21 July 2020

Product Change Notice

Part Series Affected: Ohmite-825,850 ARCOL-HS 25, HS 50,

Current Tooling:

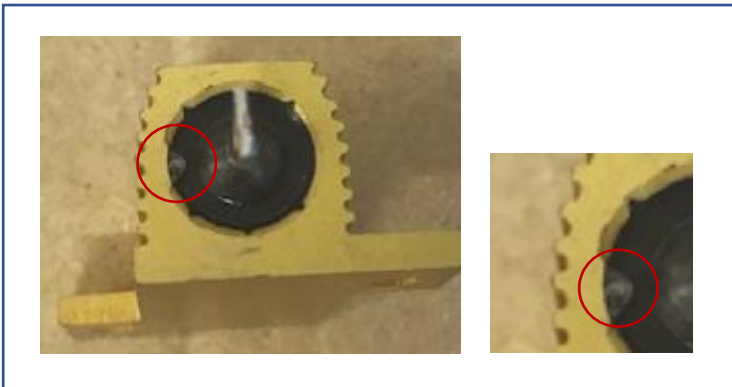
The Ohmite 825, 850 series and the ARCOL HS 25, HS 50 aluminum housed resistors have undergone a process change. This process change is regarding molding and do not adversely affect form / fit or function of the part. This is a visual change only. This change only affects the shape and position of the resin feeder. This will only affect the batches which are molded with the new tooling. Parts will continue to be produced on current tooling as well so parts may be mixed with new and current tooling.
